Memo

From: Transport Development Control
To: Jonathan Markwell Jonathan.Markwell@reading.gov.uk
Date: 8 July 2026
Re: Transport Development Control response to the Updated Design Codes in connection with the development proposals at Forbury Retail Park (Ref. PL/25/1706).

5.2.4 Eastern Square

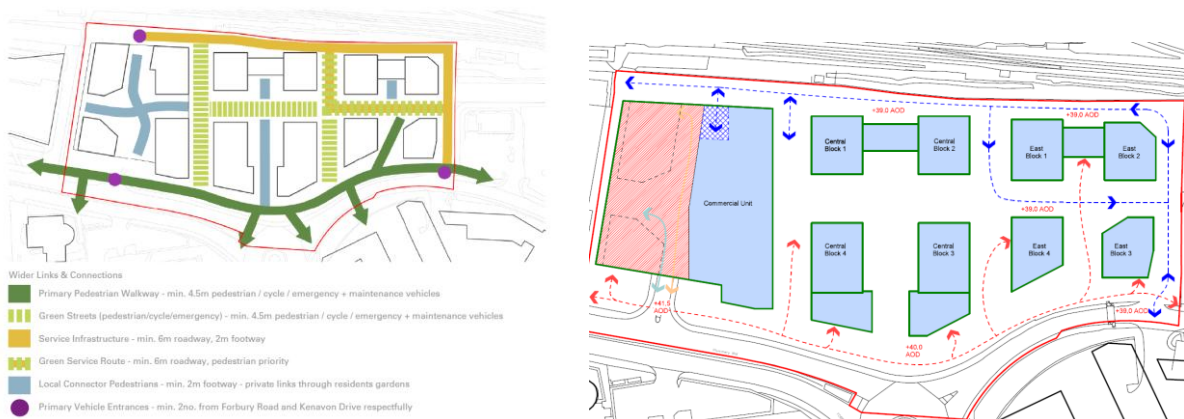
The diagram in 5.2.4 indicates that the eastern square will function as a primary pedestrian/cycle route, while also accommodating a service access route. However, it is not clear how both functions will operate within the same space without compromising pedestrian/cycling safety and servicing requirements. The Design Codes have been updated but it does not appear that the applicant has commented on this point.
